DART AEROSPACE LTD	Work Order:	97421
Description: Crosstube Assembly (412 High Aft)	Part Number:	D412-664-243
Inspection Dwg: D412-664-243 Rev: E		Page 1 of 2

DESIGN	PH	DART AEROSPACE LTD	
DRAWN	RF	HAWKESBURY, ONTARIO, CANADA	
CHECKED	Q	DRAWING NO.	REV. E
MFG. APPR.	DS	D412-664-243	SHEET 3 OF 4
APPROVED	MP	TITLE	SCALE
DE APPR.	MP	CROSSTUBE ASSEMBLY (412 HI AFT)	NTS
DATE	09.09.30	<small>COPYRIGHT © 2001 BY DART AEROSPACE LTD THIS DOCUMENT IS PRIVATE AND CONFIDENTIAL. AND IS SUPPLIED ON THE EXPRESS CONDITION THAT IT IS NOT TO BE USED FOR ANY PURPOSE OR COPIED OR COMMUNICATED TO ANY OTHER PERSON WITHOUT WRITTEN PERMISSION FROM DART AEROSPACE LTD.</small>

DRAWING NO. D412-664-243	TITLE CROSSTUBE ASSEMBLY (412 HI AFT)	REV. E	DART AEROSPACE LTD ENGINEERING ORDER		D.E.O. NO. D412-664-243-E-1	SHEET NO. SHEET 1 OF 2	SCALE NTS
DRAWN	CHECKED <i>MP</i>	MFG. APPR. <i>E</i>	APPROVED <i>MP</i>		DE APPR. <i>MP</i>		
DATE 11.03.31	DATE 11/03/31	DATE 11.03.31	DATE 11/03/31		DATE 11.03.31

DRAWING NO. D412-664-243	TITLE CROSSTUBE ASSEMBLY (412 HI AFT)	REV. E	DART AEROSPACE LTD ENGINEERING ORDER		D.E.O. NO. D412-664-243-E-4	SHEET NO. SHEET 1 OF 3	SCALE NTS
DRAWN <i>q</i>	CHECKED <i>A</i>	MFG. APPR.

SECTION A-A
CHAFING SHIELD DETAIL
VIEW ROTATED, NOT TO SCALE

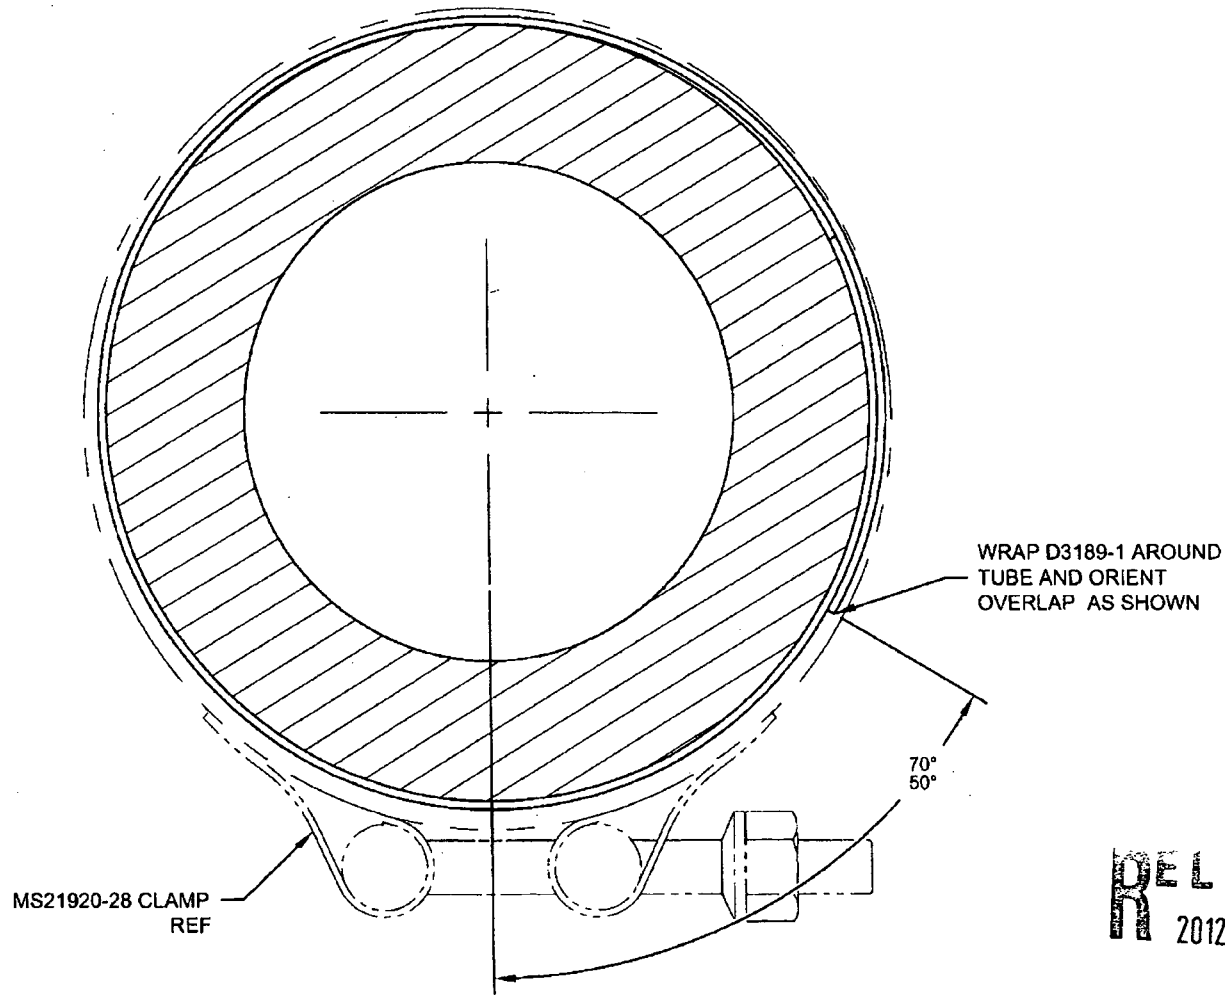
REMOVED ABRASION STRIP IN FAVOR OF A THIN LAYER OF PROSEAL 890. UPDATE INSTALLATION OF CHAFING SHIELDS AND REDUCE TORQUE TO 40-50 IN-LBS. THIS ENGINEERING ORDER SUPERCEDES DEO D412-664-243-E-1.

- 2) FINISH: CHEMICAL CONVERSION COAT PER DART QSI 005 4.1
PRIME INSIDE AND OUTSIDE PER DART QSI 005 4.2
MASK UNDERSIDE OF CROSSTUBE AS SHOWN (HATCHED AREA)
PAINT OUTSIDE PER DART QSI 005 4.2
AFTER PAINTING, APPLY CLEAR COAT ON HATCHED AREA
- 14) APPLY A THIN COAT OF PROSEAL 890 ON INSIDE CONCAVE SURFACE OF D3189-1 CHAFING SHIELD AND LET CURE PER MANUFACTURER'S INSTRUCTIONS. INSTALL PROSEALED D3189-1 CHAFING SHIELD ONTO CROSSTUBE BY APPLYING A THIN COAT OF PROSEAL 890 ONTO CROSSTUBE. BE SURE TO ELIMINATE ANY AIR GAPS.
- 16) TORQUE CLAMPS ON D2896-1 SUPPORT 80 TO 100 IN-LB. **TORQUE CLAMPS ON D3189-1 CHAFING SHIELD 40 TO 50 IN-LB.** ENSURE AT LEAST 1.5 THREADS SHOWING IN SAFETY AND THAT NUT HAS NOT BOTTOMED-OUT AFTER TORQUING.
